DEVELOPMENT APPLICATION ASSESSMENT REPORT

Application Number:	DA2024/1377
----------------------------	-------------

Responsible Officer:	Anaiis Sarkissian
Land to be developed (Address):	Lot 2 DP 224548, 20 Rednal Street MONA VALE NSW 2103 Lot LIC 613884, 20 Rednal Street MONA VALE NSW 2103
Proposed Development:	Alterations and additions to a dwelling house including a shed
Zoning:	C4 Environmental Living
Development Permissible:	Yes
Existing Use Rights:	No
Consent Authority:	Northern Beaches Council
Land and Environment Court Action:	No
Applicant:	Anthony Dudley James Saddington

Figure 1: DA2022/0953 stamped section plan

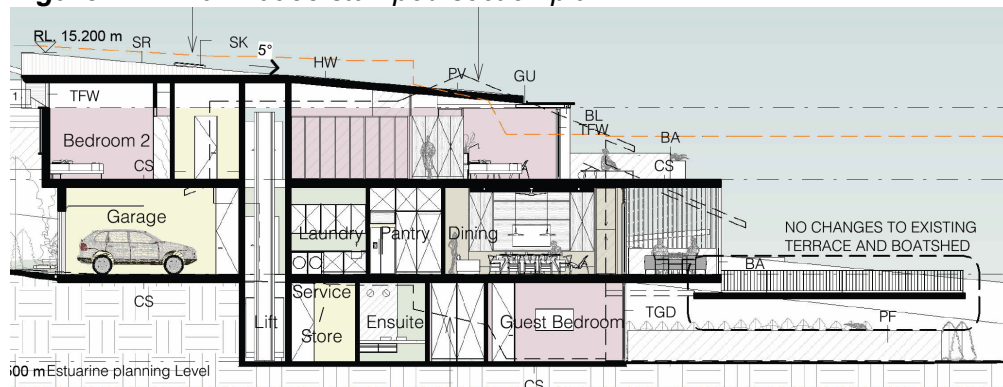
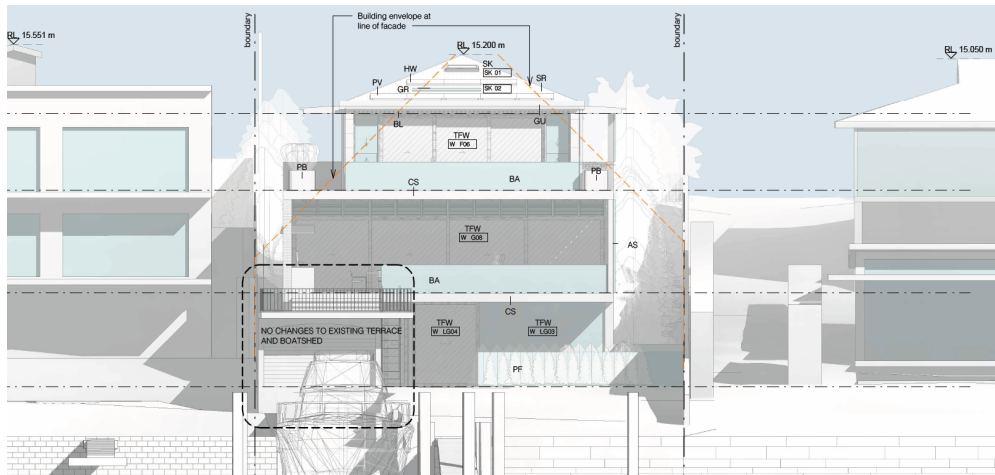
The submission raised concerns that the proposed development is inconsistent with the existing and desired future character of the locality. The extent of the additions add to an already large and bulky three storey residential dwelling. The plans do not include any remediation of the incursions of boundary fences and private outdoor space into Crown land. The proposal exacerbates the existing building height breach and will have a greater visual impact when viewed from the public waterway. The proposal is not consistent at all with structures on surrounding properties.

The consent to, stamped plans for DA2022/0953 at 18 Rednal Street in Figures 1 and 2 below show that the neighbouring dwelling house is also three storeys in height, and presents as three storeys from the foreshore. As such, the existing dwelling is not inconsistent with the character of the adjoining dwelling as viewed from the waterway. A number of other properties along this side of Rednal Street also present as several storeys from the waterway.

The approved neighbouring dwelling at 18 Rednal Street also exceeds the building height and envelope controls, with a maximum height of 9.65m. By comparison, the proposed alterations and additions as amended have a maximum height of 9.3m. It is noted that the original design had a building height of 9.8m. The variation proposed to the building height standard is addressed in detail under Section 4.6 of this assessment report.

Figure 3: Original design and foreshore building line location

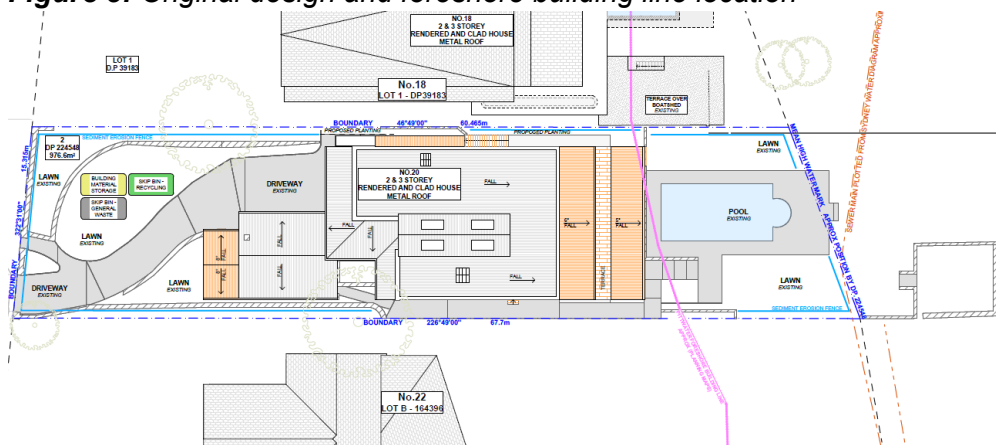
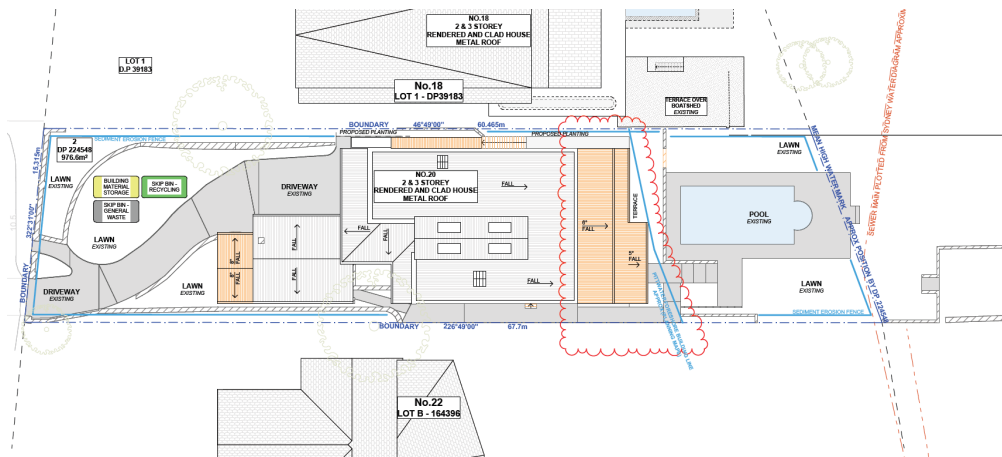
The submission raised concerns that the Applicant has shown the foreshore building line in the wrong location, resulting in a very significant proportion of the proposed works extending beyond the foreshore building line. The development results in the footprint of the building extending further into the foreshore area. There is no reference as to how the setout of the foreshore building line was determined.

Amended plans submitted on 18 December 2024 reduce the extension of the rear addition towards the foreshore and more accurately notate the location of the foreshore building line on the floor plans. The amended design no longer extends portions of the development that are restricted by Clause 7.8 into the foreshore area, as evident in Figure 3 and 4 below. The foreshore building line is taken as accurately as possible from the Foreshore Building Line Map available on the online mapping system on Council's website, and there are no specific coordinates available for its exact location.

Figure 10: Original NW elevation

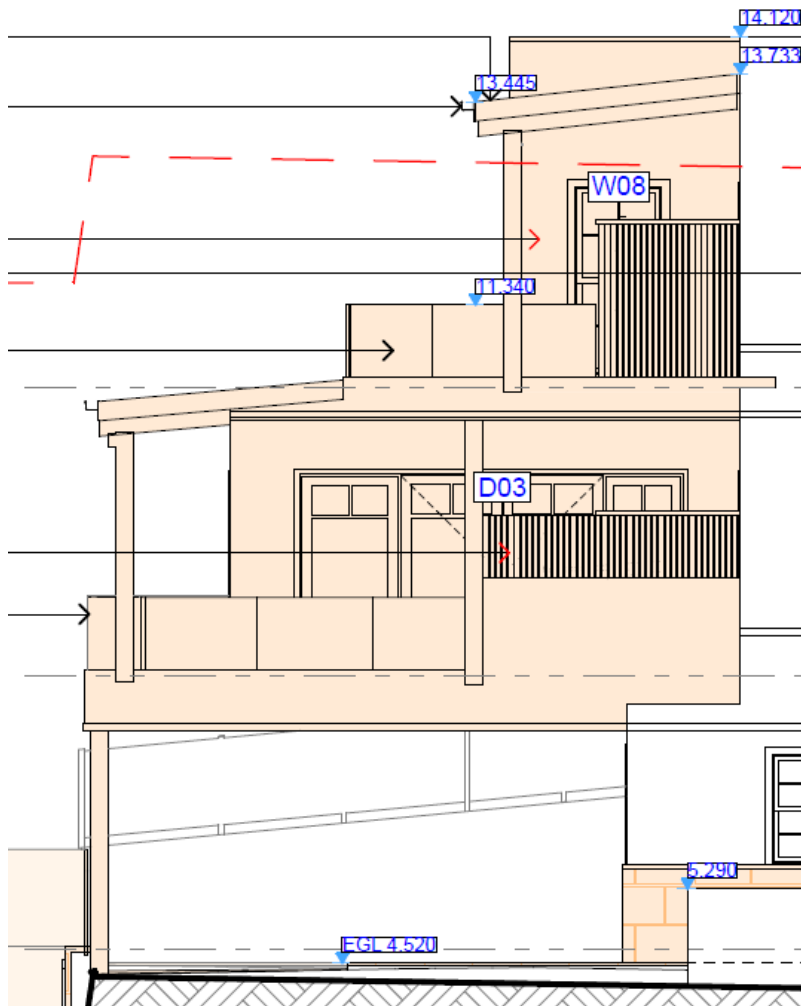
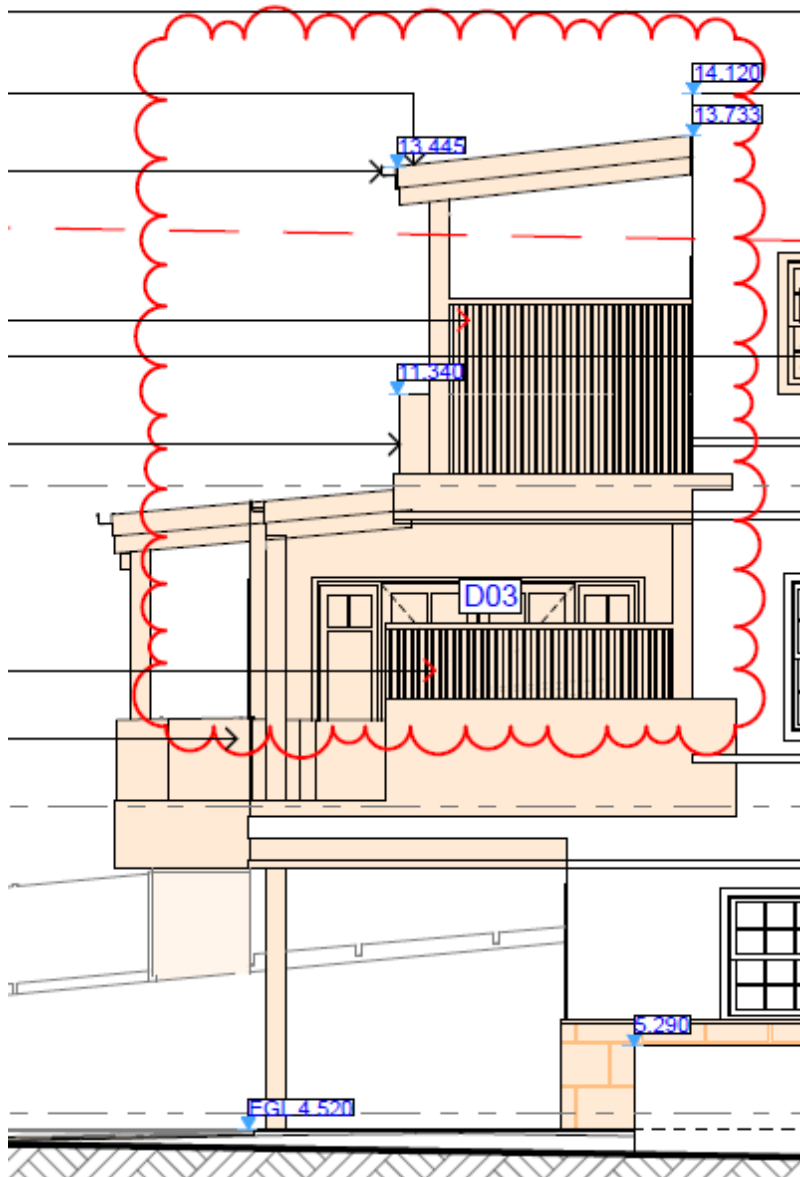
The submission raised concerns over the devastating visual privacy impacts of the proposed development on 18 Rednal Street. The 2.7m long privacy screen to the north-western elevation of the ground floor balcony does not extend the entire length of the balcony, which is approximately 6.85m. The first floor balcony extends approximately 2.6m east of the existing first floor balcony. A small privacy screen extending approximately 1.5m is shown on the northern edge of the proposed first-floor balcony, but this leaves approximately 2.6m of unprotected balcony.

Amended plans submitted on 18 December 2024 demonstrate that the ground floor balcony towards the north-western half of the site is now to be retained as existing, meaning that the length of the balcony now extends only 4.1m rather than 6.7m. The amended plans include privacy screening to a height of 1.7m for a length of 2.7m. Privacy screening to the full length of the ground floor balcony at the north-western elevation is not considered necessary given the balcony does not extend past the ground floor balcony at 18 Rednal Street, and this is a blank

The amended plans reduce the depth of the original first floor balcony design by 1.3m, thereby only extending 1.3m east of the existing first floor balcony, rather than 2.6m, as originally proposed. The amended design includes 1.7m high privacy screening to almost the entire length of the first floor balcony at the north-western elevation, with a length of approximately 2.3m rather than 1.5m, as shown in Figure 11 below. The amended proposed provides a much more positive design with respect to visual privacy and overlooking in comparison to the original proposal, as evident in Figures 10 and 11 below.

Figure 13: Section plan showing proposed alterations and additions in orange at a maximum height of 9.3m

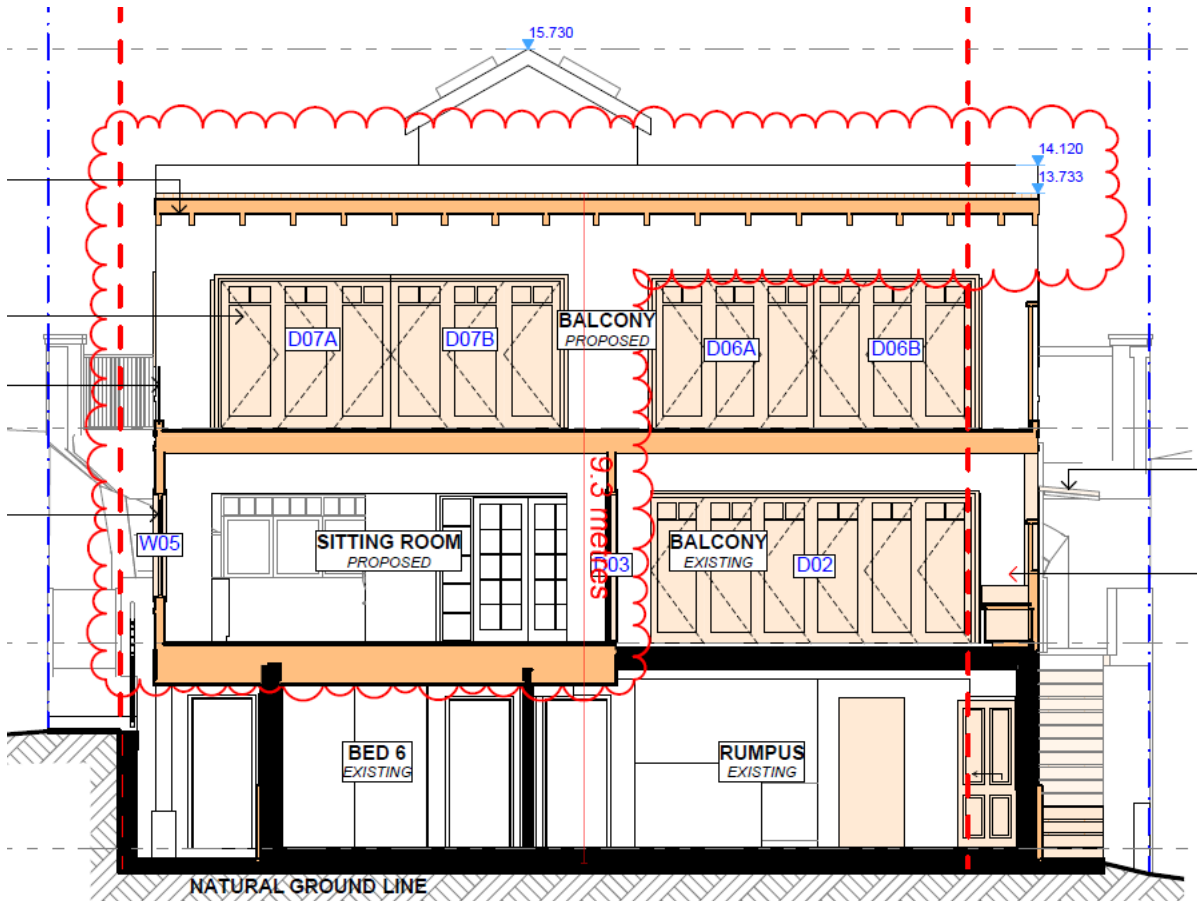
Requirement: 8.5m
Proposed: 9.3m
Percentage of variation: 9.4%

Figure 14: Site Plan

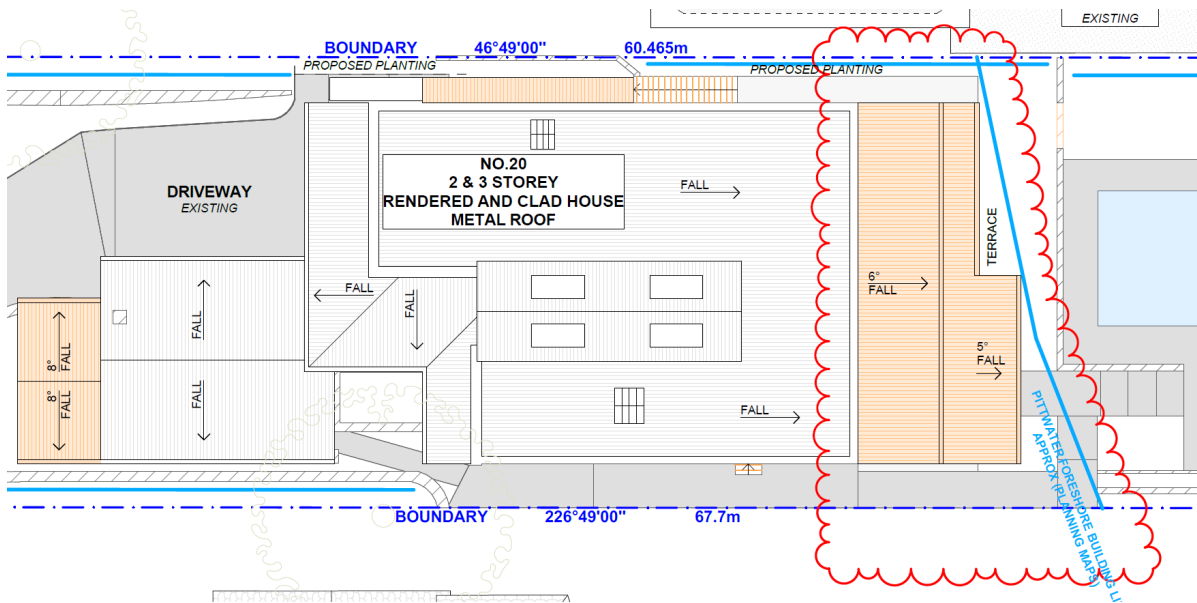
The proposed development is for alteration of an existing dwelling house partly in the foreshore area, including a rear extension, and will not result in the footprint of the building extending further into the foreshore area, as evident in the site plan at Figure 14 below. The foreshore building line is shown in light blue and the proposed works are shown shaded in orange, behind the foreshore building line.

Figure 15: Proposed SE elevation

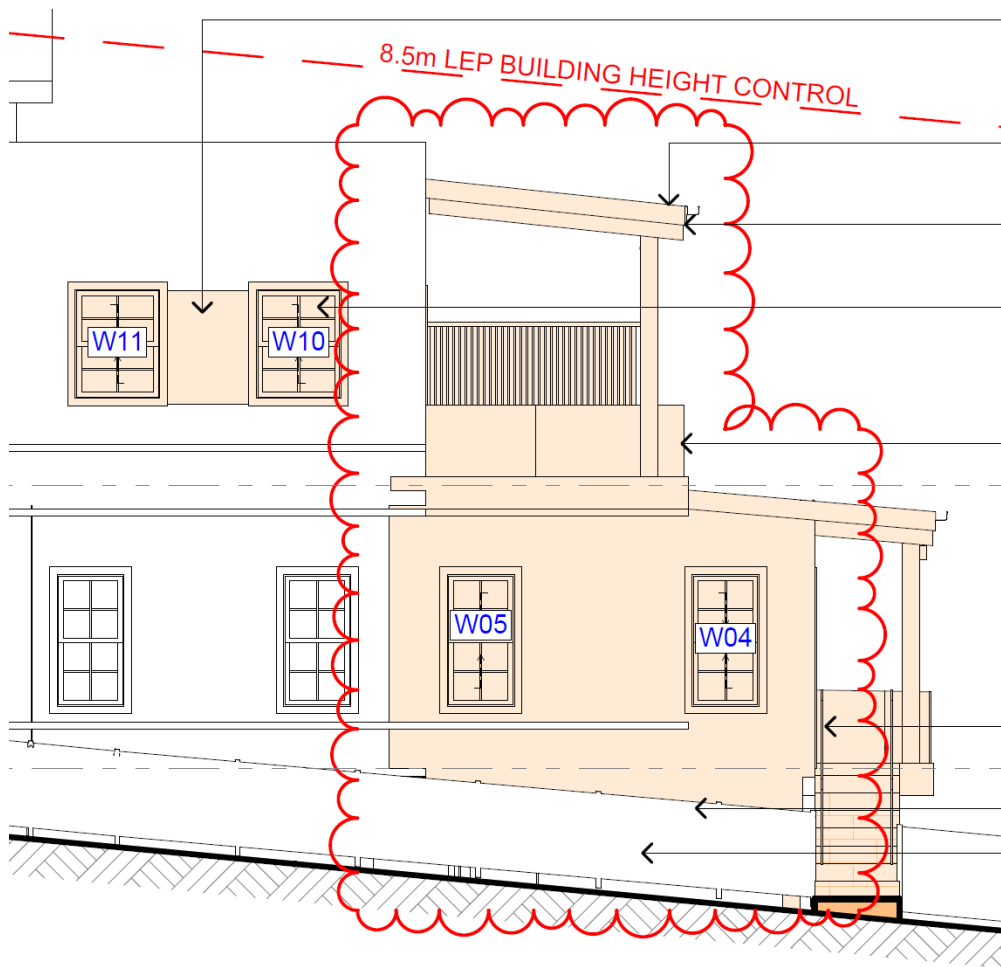
The proposed sitting room at the ground floor sits approximately 3m from the elevated private open space area to the rear of 22 Rednal Street. As such, a condition has been included requiring windows 4 and 5 to have obscure glazing. The proposed first-floor balcony extension incorporates a 1.7m high privacy screen across almost the entire south-eastern elevation (refer Figure 15). Windows 10 and 11 have a reduced degree of glazing compared with the existing condition and are therefore acceptable. Windows 10 and 11 are also to the master bedroom, which is a low-use room.

Figure 16: Proposed NW elevation

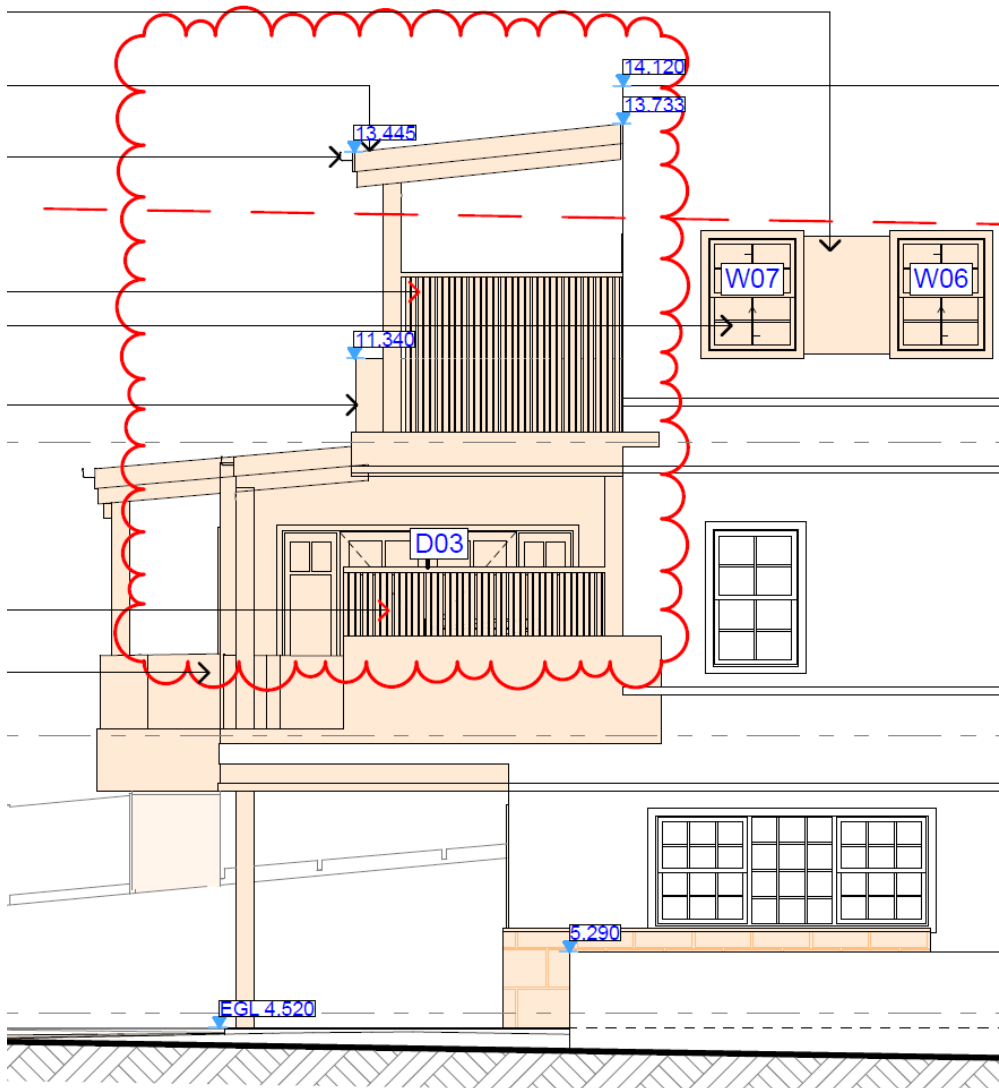
The amended plans include privacy screening to a height of 1.7m for a length of 2.7m along the ground floor balcony at the north-western elevation. Privacy screening to the full length of the ground floor balcony at the north-western elevation is not considered necessary given the balcony does not extend past the ground floor balcony at 18 Rednal Street, and this is a blank wall, as shown in Figure 18 below. As such, there would be no direct sightline from the ground floor balcony at the subject site to the neighbouring ground floor balcony. It is also important to note that the proposal reflects the existing condition of the ground floor balcony in terms of the extension of the balcony and privacy screening, as evident in Figure 17 below.

The amended plans also reduce the depth of the original first floor balcony design by 1.3m, thereby only extending 1.3m east of the existing first floor balcony, rather than 2.6m, as originally proposed. The amended design includes 1.7m high privacy screening to almost the entire length of the first floor balcony at the north-western elevation, with a length of approximately 2.3m rather than 1.5m, as shown in Figure 16 below. Windows 7 and 8 have a reduced degree of glazing compared with the existing condition and are therefore acceptable. Windows 7 and 8 are also to bedroom 2, which is a low-use room.

Figure 20: Proposed Ground Floor Plan

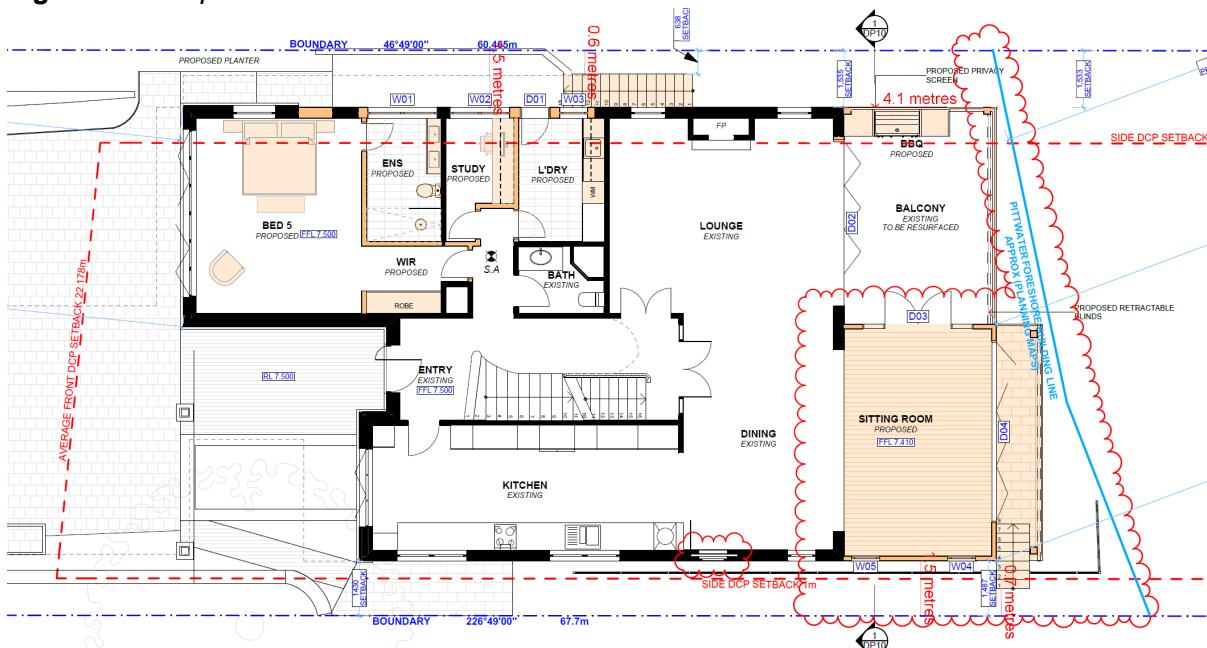
For this site, the 2.5m requirement is taken to be for the north-western boundary and the 1m requirement is taken to be for the south-eastern boundary. The proposed new dwelling includes external access stairs, which have a 0.6m setback from the north-western boundary and a 0.7m setback from the south-eastern boundary, representing technical non-compliances of 76% and 30%, respectively.

However, it is important to note that the alterations and additions otherwise maintain the existing main building lines of the dwelling, being 1.5m from both side boundaries, as evident in Figure 20 below. Furthermore, the external stairs are low-lying, lightweight structures that provide direct access to and from the laundry and balcony.
